TOWN OF BAY HARBOR ISLANDS
DEVELOPMENT & REVIEW COMMITTEE MEETING
THURSDAY, MAY 11, 2023

Subject: Site Development Plan Application (2023 New Design)
Casa Verde Condominiums – Multifamily Residential Complex (43 DU)
1130 – 1140 - 1150 93rd Street
Bay Harbor Islands Acct. No. SPR23-000019
MMPA Acct. No. 01-0702-1165

**Town of Bay Harbor Islands
Site Development Plan Application
Casa Verde Condominiums - Multi-Family Residential (43 DU)
1130 – 1140 - 1150 93rd Street
Development Review Committee (DRC) Staff Report
May 8th, 2023
Page 2**

DRAWING TITLE
ROOF PLAN

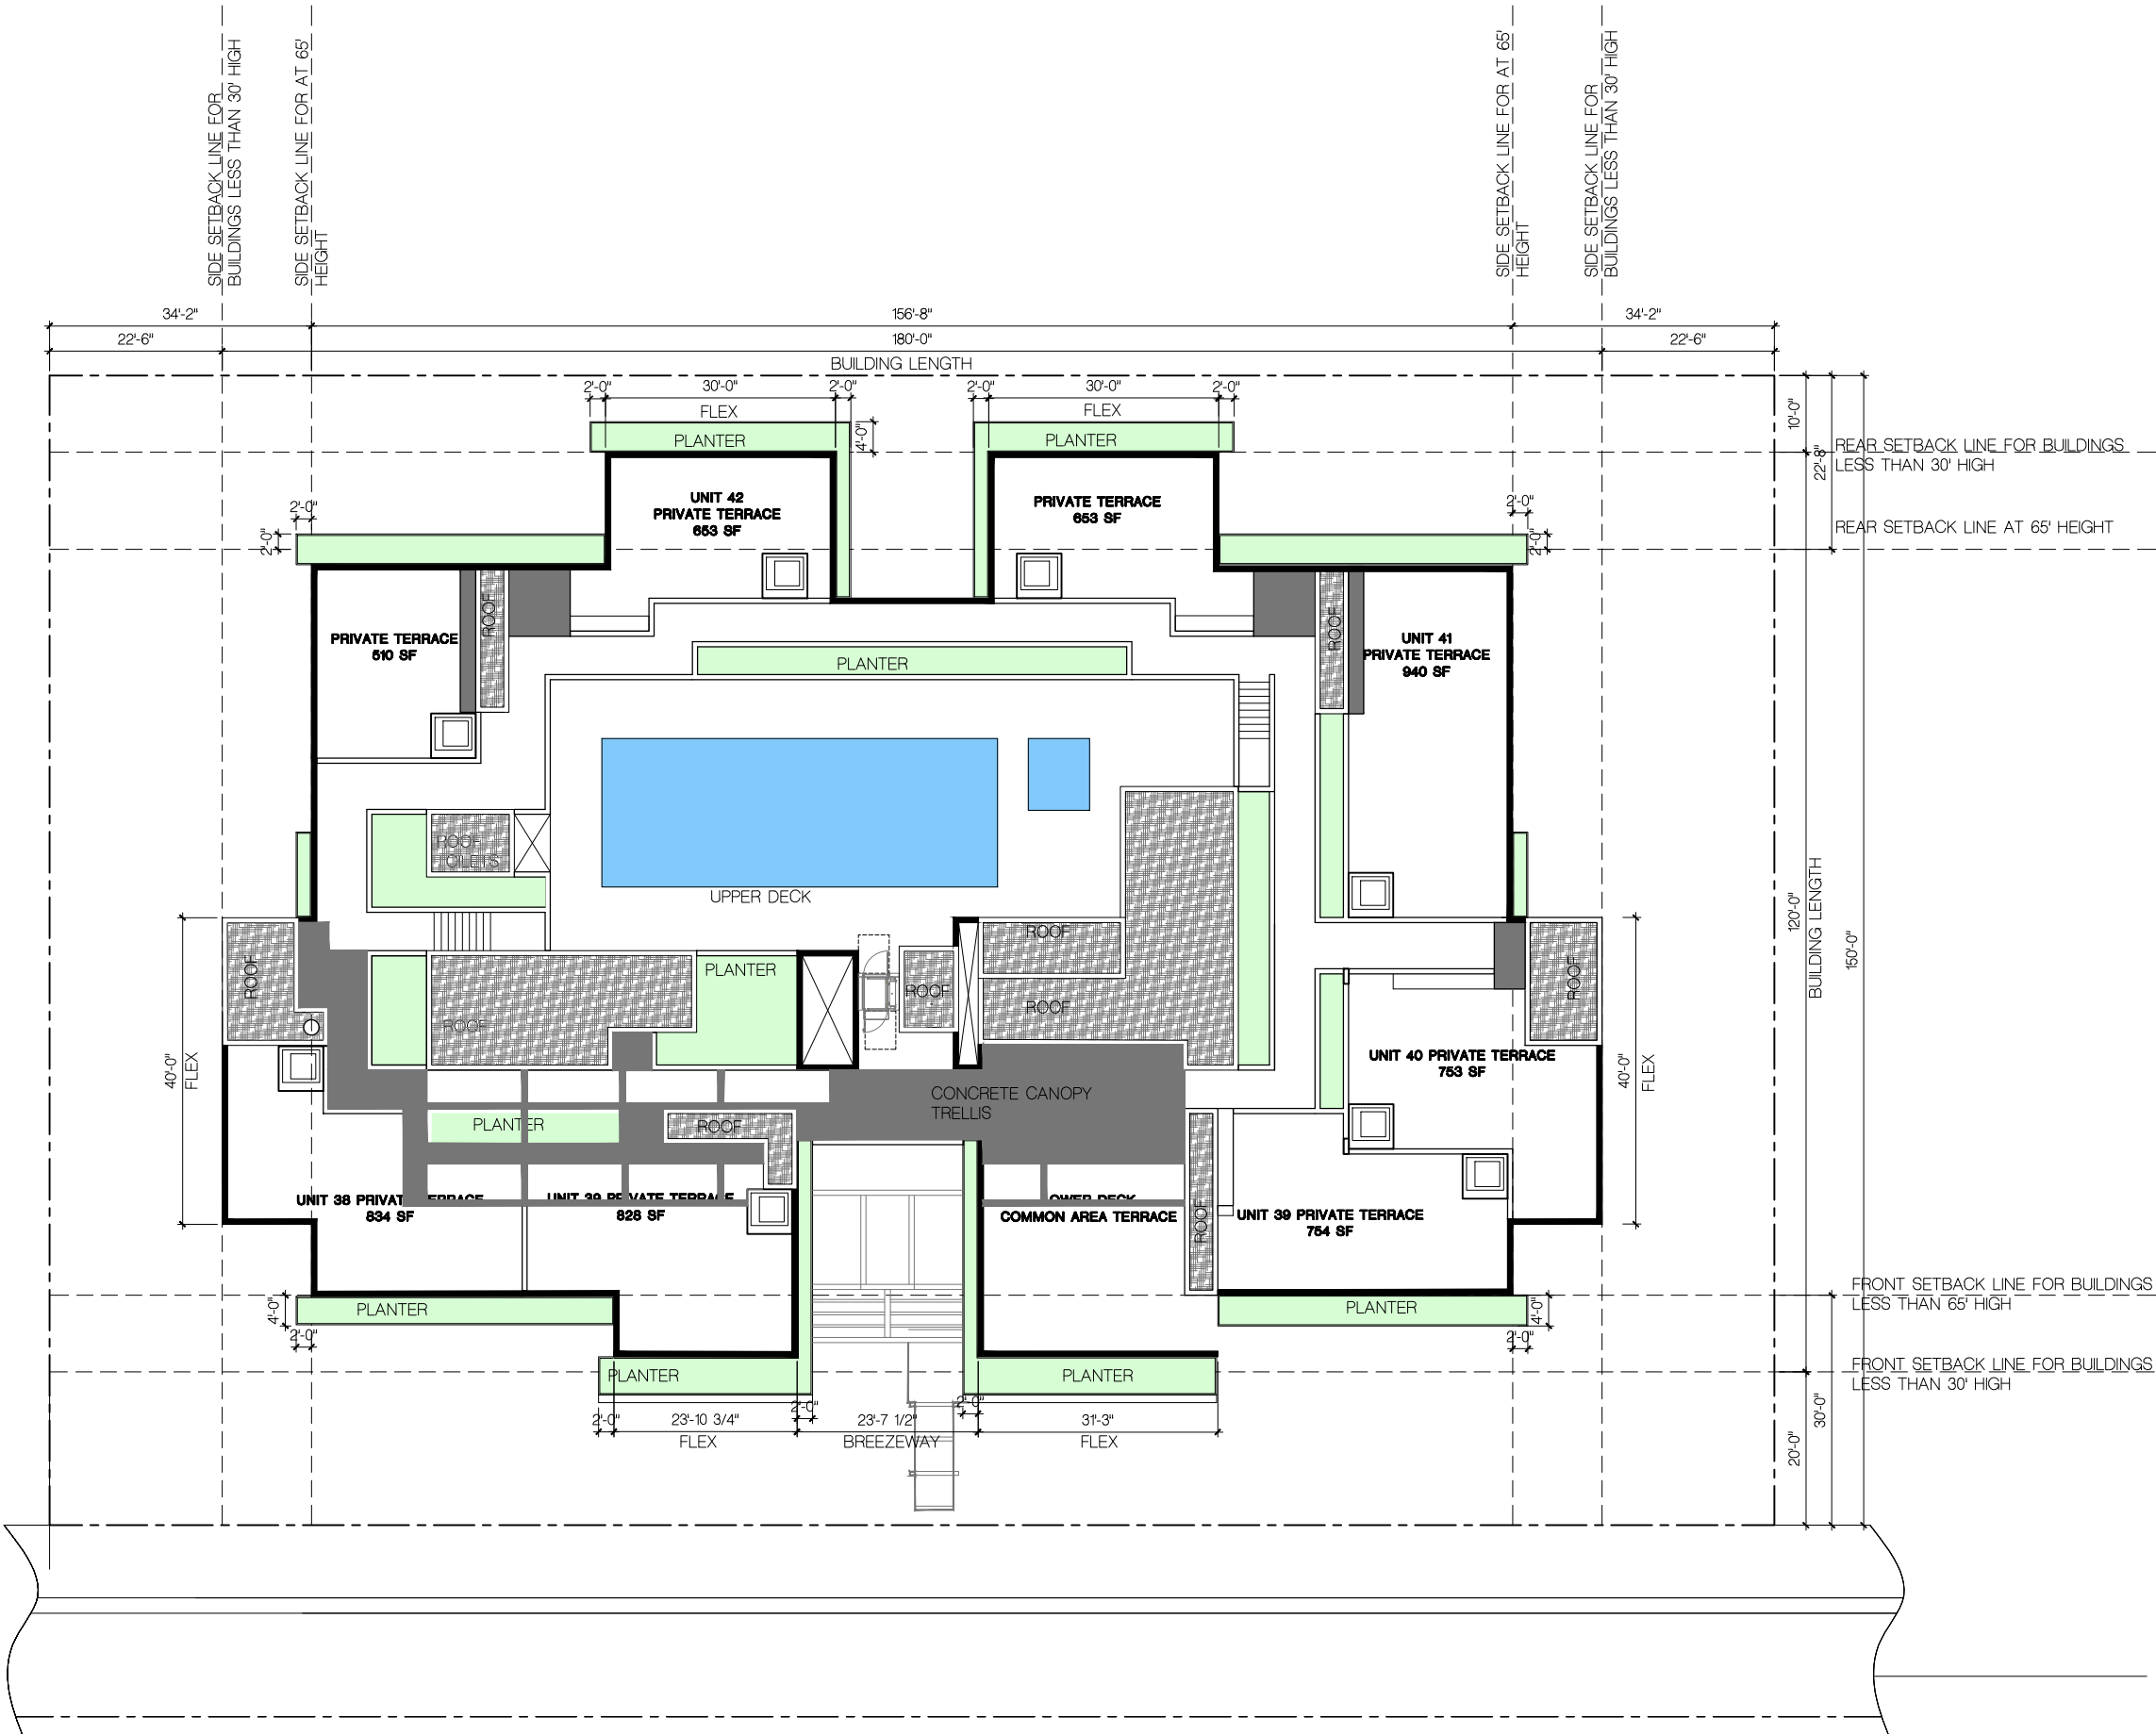
- 16) On Sheet A-1.08 Rooftop Plan a "red-lined" area is shown supposedly illustrating where the edge of Floor 7 is below the rooftop – if this were true most of the rooftop terraces would not be permitted as shown. We believe the "red line" as drawn is not shown correctly – please verify.

- Site Data for 15% of Roof Area Minimum Used for Recreation does not agree with Sheet A-1.08 Roof Plan required 1,871 vs. 1,889. Please revise.
 - Under Architecture Analysis – Unit 14 does not provide net area. Unit 24 net area does not agree 2,161 vs. 2,181. Unit 25 gross & net area does not agree.

- 20) On Sheet A-1.08 what is a "generator toilets area"? There are separate men's / women's bathrooms shown too. Please provide details.
- 21) A detail for the privacy wall, as well as the dumpster enclosure, needs to be included in the plans.
